DANE COUNTY DEPARTMENT of PUBLIC WORKS, HIGHWAY and TRANSPORTATION

RFB NO. 313086 - ADDENDUM NO. 5

ARCTIC ANIMAL EXHIBIT AND CONCESSIONS

This Addendum is issued to modify, explain or clarify the original Request for Bid (RFB) and is hereby made a part of the RFB. Please attach this Addendum to the RFB. **Bidders must acknowledge all Addenda on the Bid Form.**

**BEAR CONTAINMENT WALLS
ENLARGED LAYOUT PLAN**

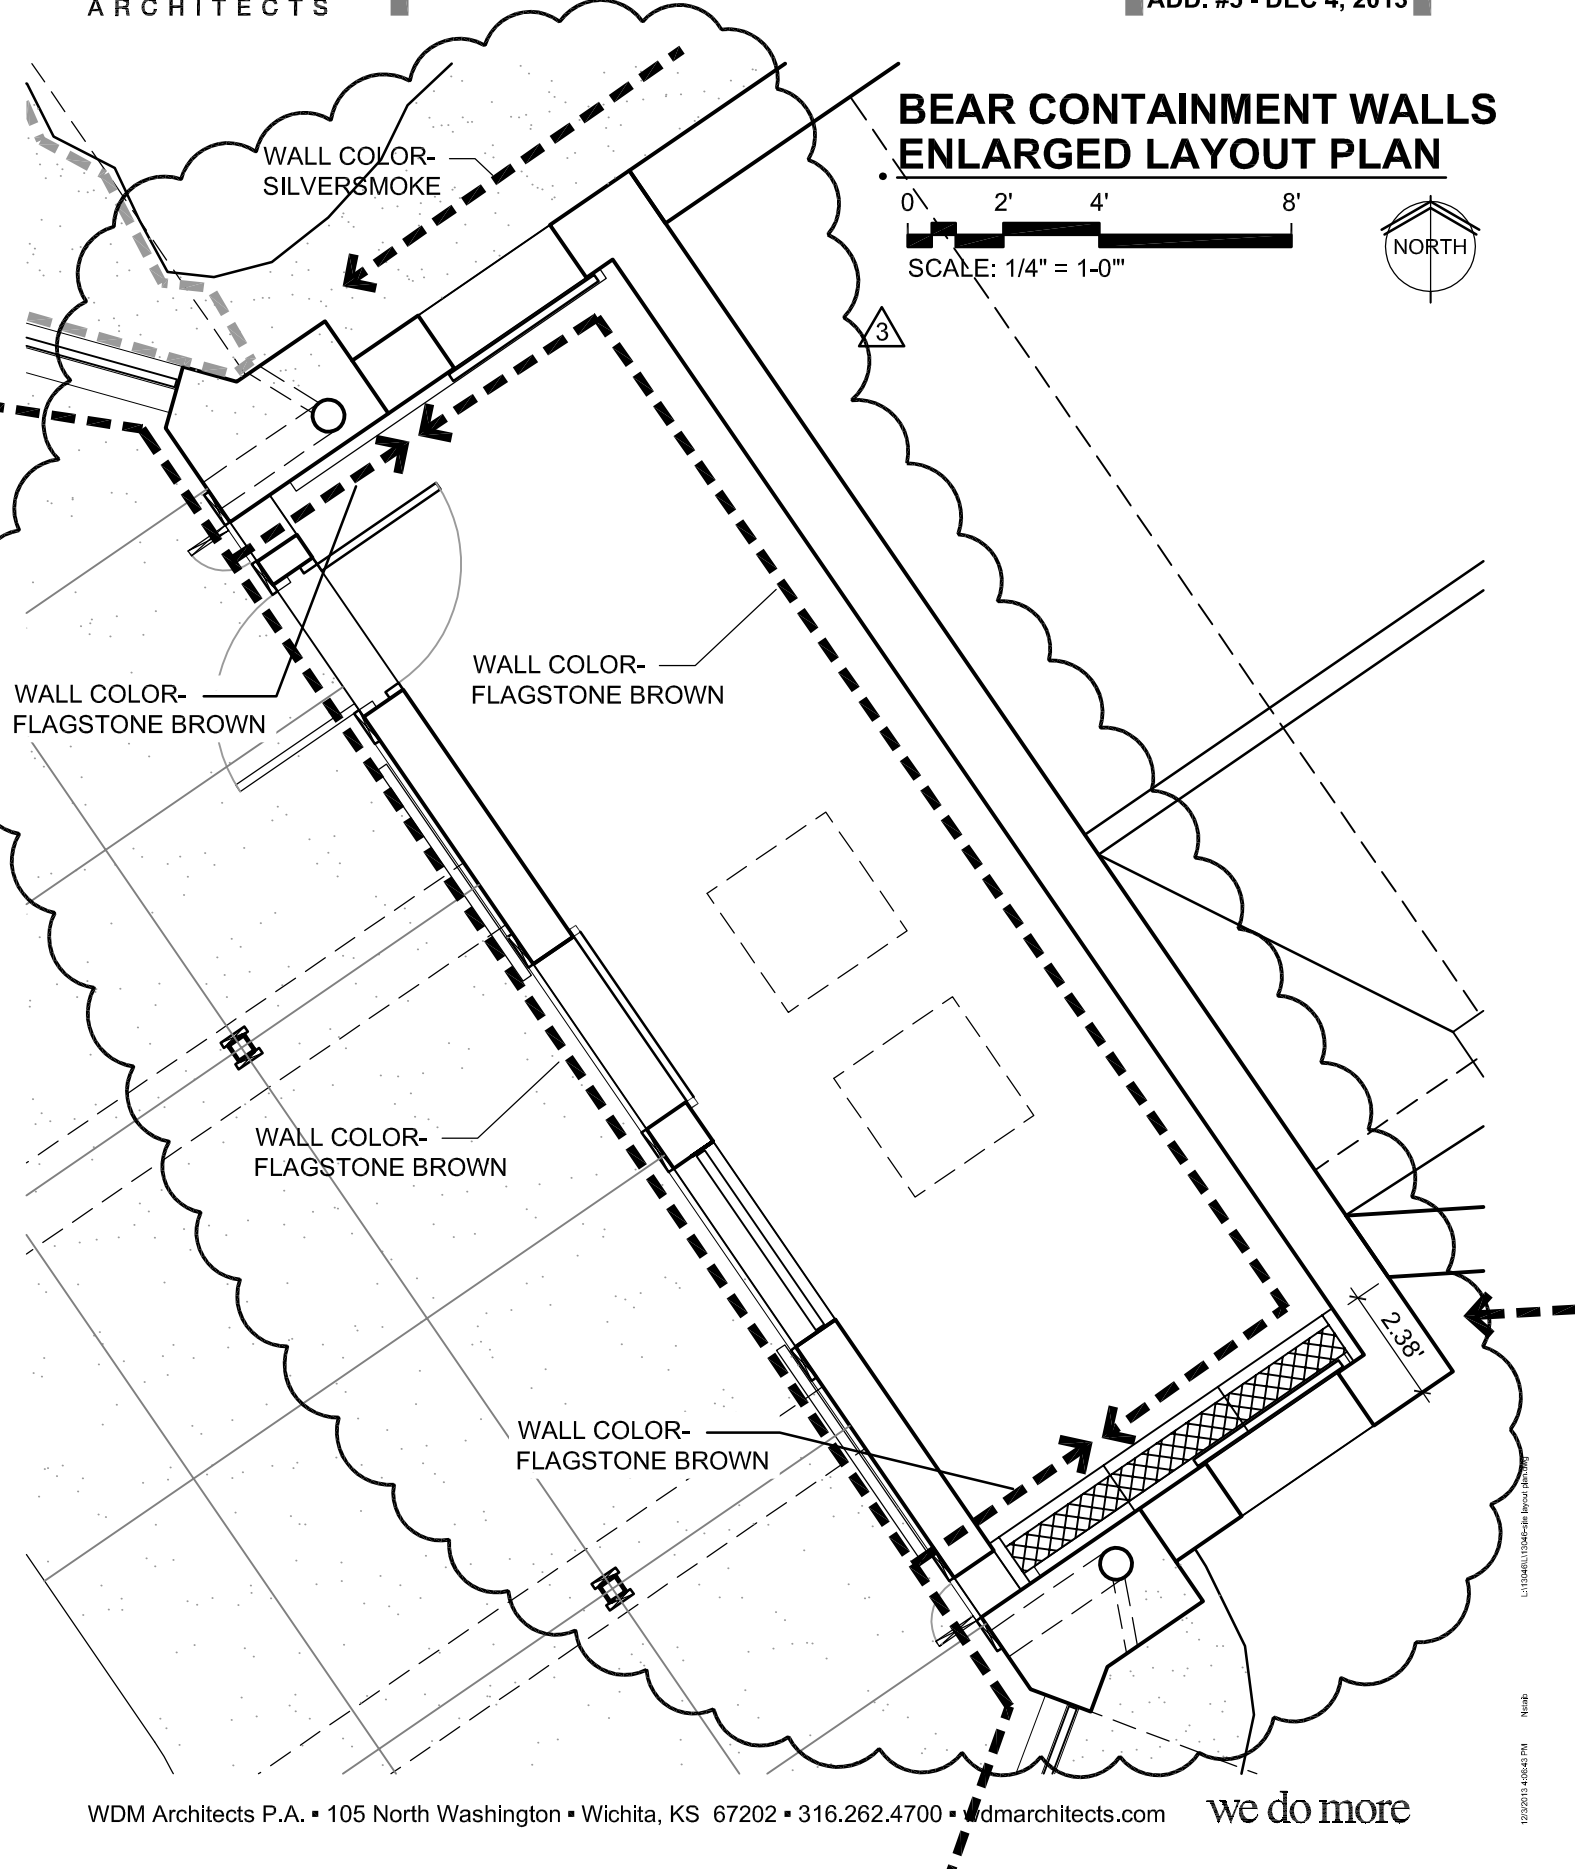
- Added detail for horizontal reveals at pool walls.

B SECTION THRU THEMEWORK
NTS

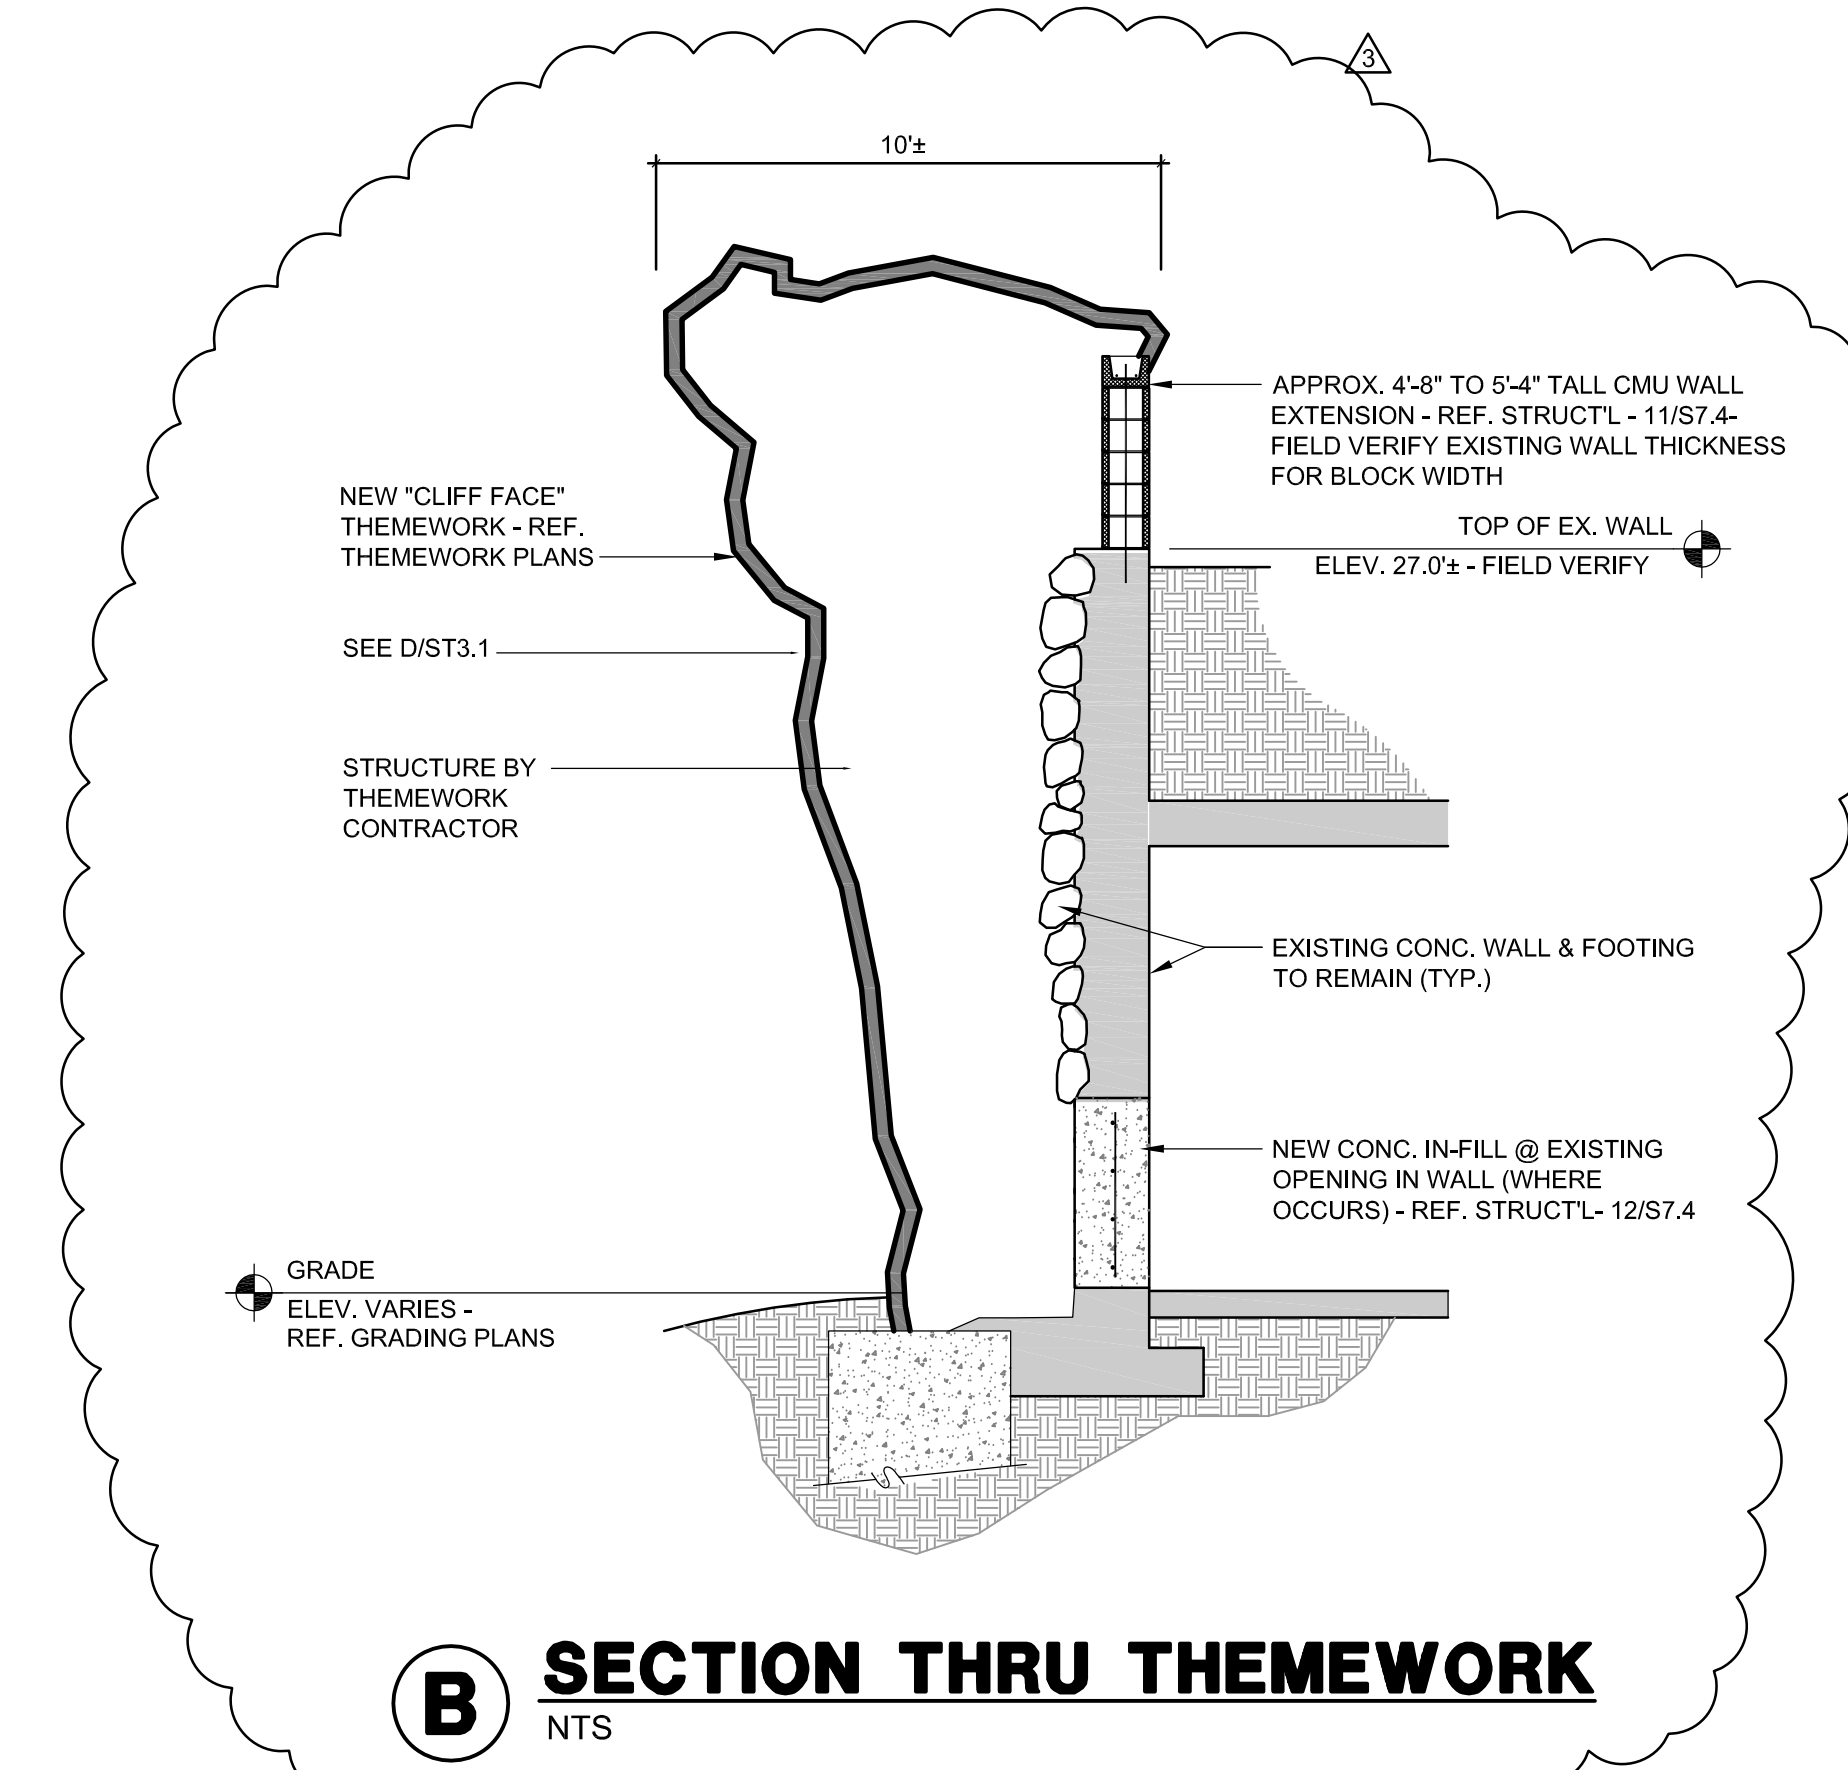
- Detail B/ST2.1 modified to include references to structural details and show themework foundations by themework contractor.
- General note added to sheet clarifying all foundations for themework structures are designed and constructed by themework contractor per the specification.
